Re: IE30.8 Queen's Park North Donation - Concept Plan Update Report

Bay Cloverhill Community Association Letter to Infrastructure and Environment Committee

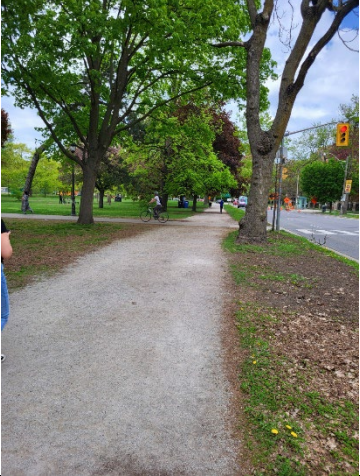
Element	Existing	Change	Concern
<p>New: Tree Walk through western quadrant</p> 	<p>Large trees</p>	<p>Tree Walk/Learning Forest: 3 m boardwalk with protected understory planting; may now be lowered to 2 m. Drawings unavailable.</p>	<p>Route through trees adjusted and length shortened. F No dimensioned drawings provided; No heritage analysis nor review of impact on the forested oasis.</p>
<p>New: Workshop</p>	<p>Soft surface</p>	<p>Space for programming</p>	<p>Plans, designs, concepts TBA</p>
<p>New: Kiosk</p>	<p>Soft surface</p>	<p>Food stall</p>	<p>Plans, designs, concepts TBA</p>
Southern section of the park			
<p>New: Commemorative Gardens</p> 	<p>Fountain to the west. Glades at south and on the east. Shady respite with open patches.</p>	<p>Commemorative Gardens Dimensioned drawings (Jan/26) withheld until FOI. Plan illustrates: large central gardens, labyrinth, Reflecting pool.</p>	<p>Glades in the south would now be removed and formal English garden installed; compressed pebbles will limit root zones; stone labyrinth will be ground heat source.</p>

<p>New: Additional cross park pathway to running from fountain, below ceremonial gardens, past labyrinth</p>	<p>Soft surface lawn and trees</p>	<p>Hard surface walk</p>	<p>Loss of soft surface which is now a place for casual resting</p>
<p>New: Interactive water feature</p> 	<p>Presently soft landscaping extends to the statue of the horse</p>	<p>Various pedestals and water fountains</p>	<p>Increasing hard surface</p>
